HISTORIC AND DESIGN REVIEW COMMISSION

December 01, 2021

HDRC CASE NO: 2021-605
ADDRESS: 828 NEVADA
LEGAL DESCRIPTION: NCB 3100 BLK LOT 8
ZONING: RM-4
CITY COUNCIL DIST.: 2
APPLICANT: Anthony Chen
OWNER: JCCH PROPERTY SOLUTIONS LLC
TYPE OF WORK: Window replacement
APPLICATION RECEIVED: November 08, 2021
60-DAY REVIEW:
CASE MANAGER: Hannah Leighner

REAR ELEVATION

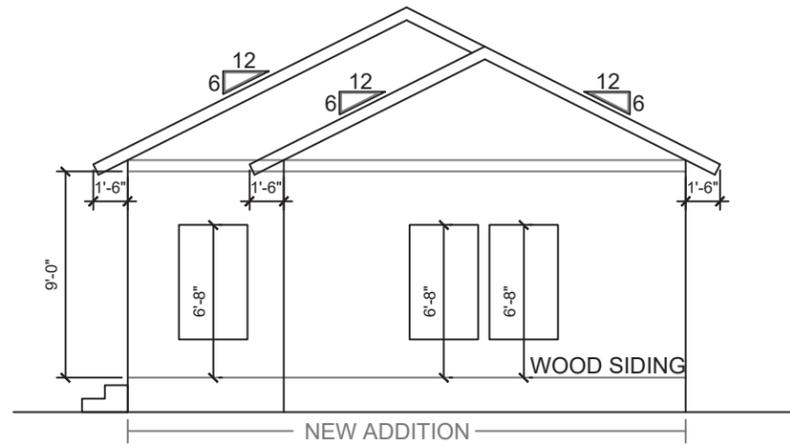
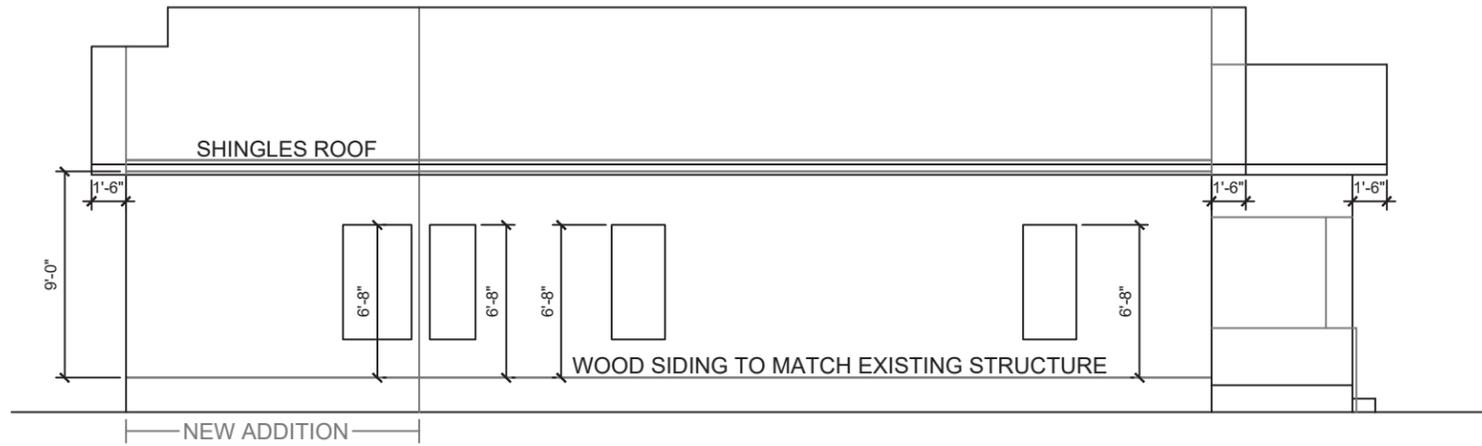
- k. NEW WINDOW INSTALLATION: The applicant is proposing to install three new windows on elevation of the rear addition. The addition encloses two existing wood windows. The Historic D Guidelines for Additions 3.C.i recommend to salvage and reuse historic materials, where possible covered or removed as a result of an addition. Staff finds relocation of the two original windows addition exterior to be consistent with the guidelines.

1. Staff does not recommend approval of item 1, replacement of the wood windows. Staff recommends that the wood windows be repaired to be consistent with the design guidelines.
2. Staff recommends approval of item 2 based on finding c with the stipulation that the applicant re-use the two previously-existing wood windows on the north elevation that are to be enclosed by the addition as recommended by the guidelines. Staff recommends approval of the additional third window under the stipulation that the proposed new window is consistent with the guidelines and is submitted for review by staff prior to installation.
